## STAFF REPORT

### DESIGN COMMISSION STUDY SESSION

<b>Project No:</b>	DSR20-010
<b>Description:</b>	Shell Station renovation
<b>Applicant/ Owner:</b>	Brad Kaul (Kaul Design Architecture) / Matt Randish (Sun Pacific Energy)
<b>Site Address:</b>	7833 SE 28 <sup>th</sup> St (Parcel Number 545230-0380)
<b>Zoning District</b>	Town Center (TC)
<b>Staff Contact:</b>	Robin Proebsting, Senior Planner
<b>Exhibits:</b>	<ol style="list-style-type: none"> <li>1. Conceptual Plans prepared by Kaul Design Architecture, dated February 25, 2021</li> <li>2. Project Narrative prepared by Brad Kaul</li> <li>3. Shell Convenience Store Addition Parking Memo prepared by Heath &amp; Associates, dated March 2, 2021</li> </ol>

4 WEST ELEVATION  
1/4"=1'0"

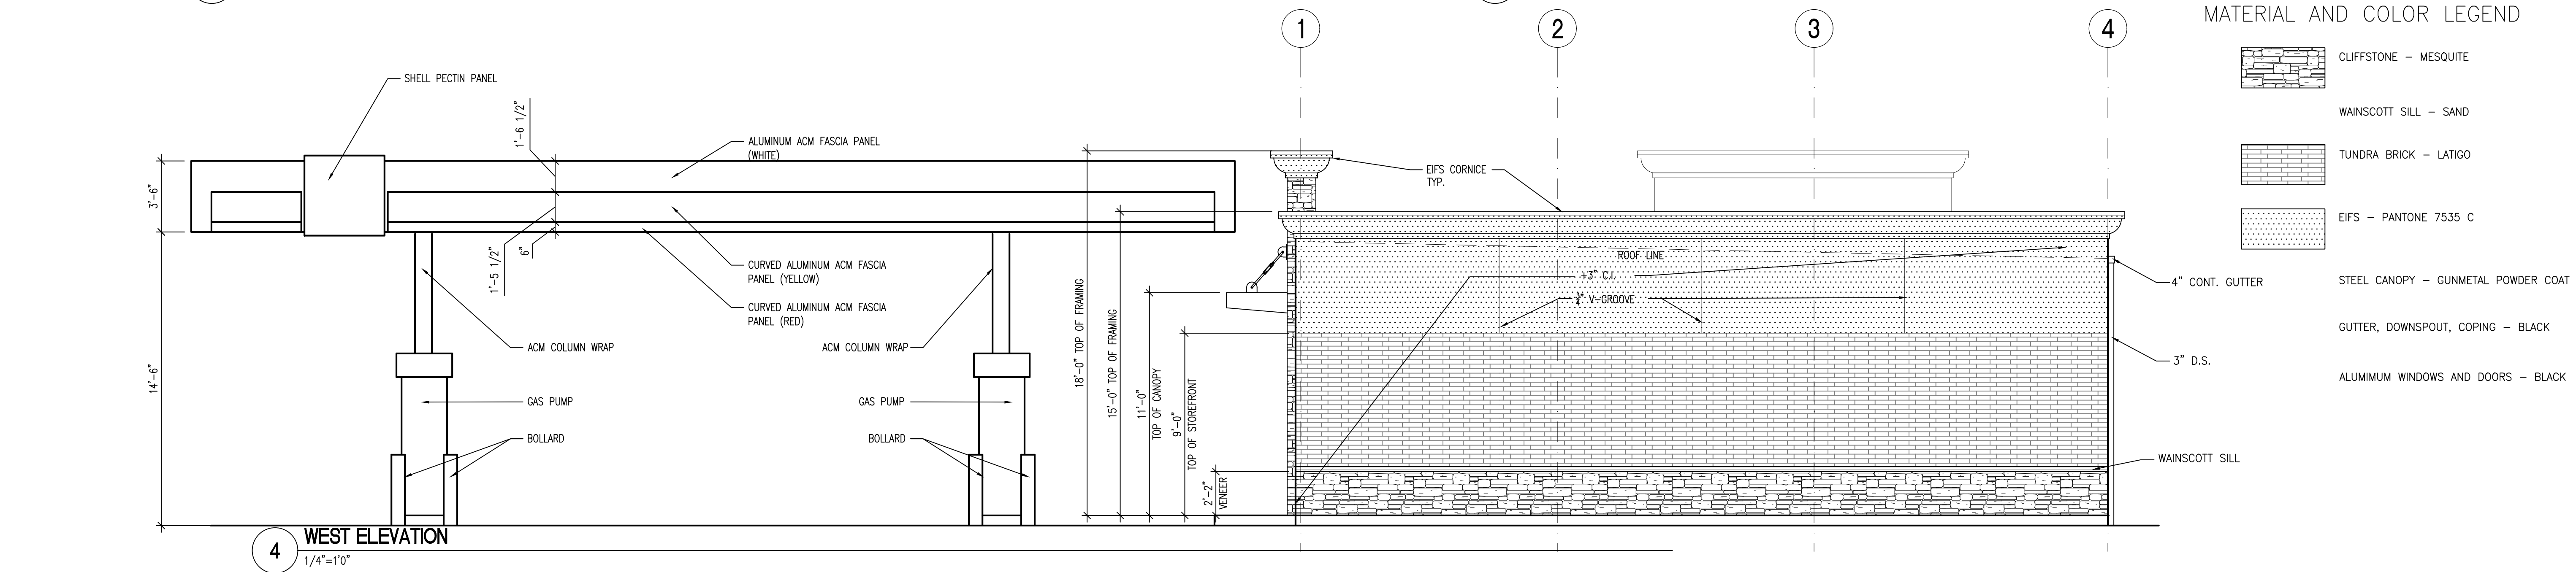
Building height is limited to 27 feet, pursuant to MICC 19.11.030(A)(1). The convenience store and fuel canopy will be 18 feet tall at their highest point, consistent with this standard (Exhibit 1, sheet A2.1).

Average Daylight Plane standards in MICC 19.11.030(A)(7) require block frontages to step back buildings at a 45-degree angle beginning at a height of 25 feet. Since all buildings will be shorter than 25 feet, this standard does not apply (Exhibit 1, sheet A2.1).

The building design section also includes a prohibition on untreated blank walls, defined as a wall (including building facades and retaining walls) over six feet in height, with a horizontal length greater than 15 feet that does not include a transparent window or door. Method to treat blank walls include 1) a landscape planting bed at least five feet wide or a raised planter bed at least two feet high and three feet wide in front of the wall with planting materials that are sufficient to obscure or screen at least 60 percent of the wall's surface within three years and 2) a vertical trellis in front of the wall with climbing vines or plant materials. The north and east elevations of the convenience store will not have any blank areas more than 15 feet in width (Exhibit 1, Sheet A2.1); the south and west elevations have blank walls greater than 6 feet by 15 feet, but these walls are partially obscured by landscaping along the south and west property lines. This item will be a discussion item at the May 13<sup>th</sup> study session.

bright colors only for trim or accent areas. The proposed material palette will use a complimentary mix of earth-toned materials, with bright colors used only to accent the Shell logo on the fuel canopy. The proposed design utilizes EIFS, which is listed as an undesired material in MICC 19.11.110(B)(7) that should be limited to use as a minor building façade element. Recall that when a standard uses the word “should,” the standard is mandatory unless the applicant can demonstrate, to the satisfaction of the design commission, an equal or better means of satisfying the standard and objective. The Design Commission has the discretion to allow the broader use of EIFS for this project if it determines that the objectives in MICC 19.11.110(A) are met, which include use of textured, high-quality materials that bring a visually interesting experience into the streetscape. This item will be a discussion item at the May 13<sup>th</sup> study session.

Town Center sign standards are contained in MICC 19.11.140 and allow one sign per business on each street frontage. A sign is defined as: “Any series of letters, figures, design symbols, lights, structure, billboard, trademark or device intended or used to attract attention to any activity, service, place, subject, person, firm, corporation, or thing”. Staff understand the Shell logo to fall into the definition of “sign”, therefore the proposed design will need to be modified to remove one of the two proposed signs on the east elevation.

E1.0

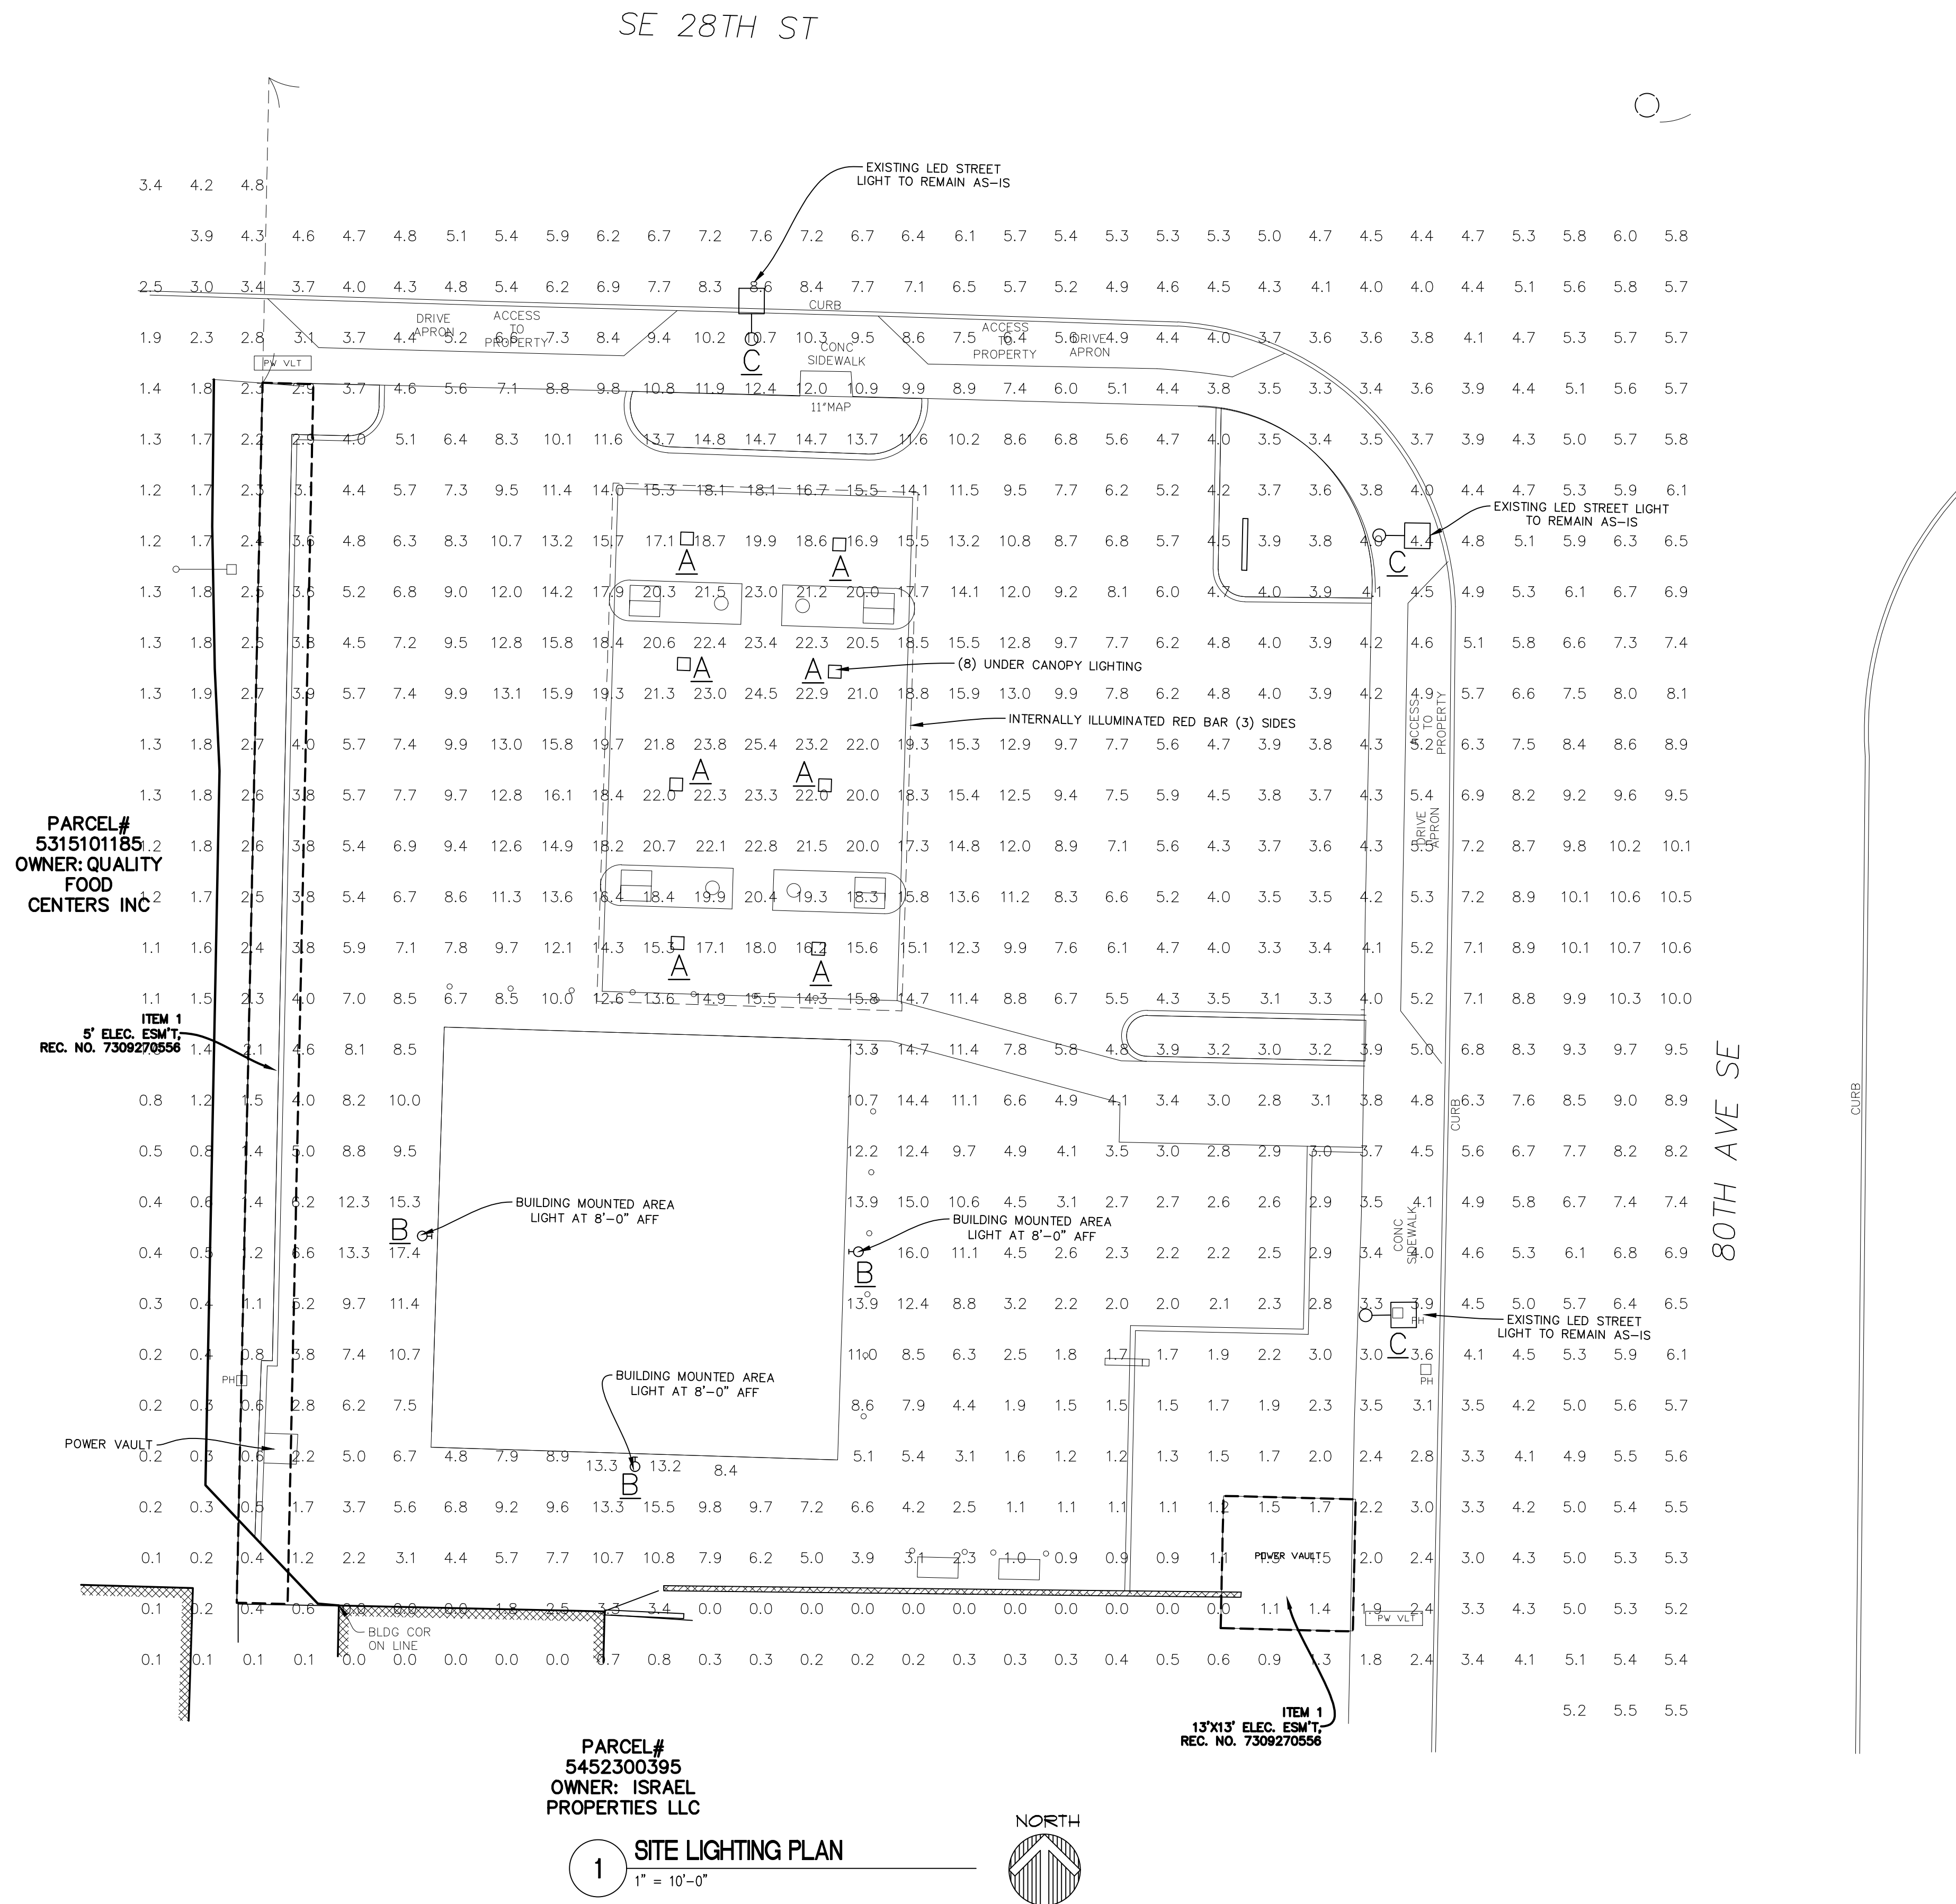
Lighting standards are contained in MICC 19.11.090. Lighting should be designed to be pedestrian scale, LED or low wattage, shielded, and integrated into the overall design. The proposed design meets the standards in this section by including light fixtures that will be 8-15 feet in height, supporting a pedestrian scale; utilizing LED lighting, as called for by code; and shielding lights by either installing them under the fuel canopy or on the building face using fixtures with a full cutoff design. According to the lighting sheet within the plan set, light levels at the property line adjacent to the building will be under 2 foot-candles, largely confining light to the property boundaries (Exhibit 1, sheet E1.0).
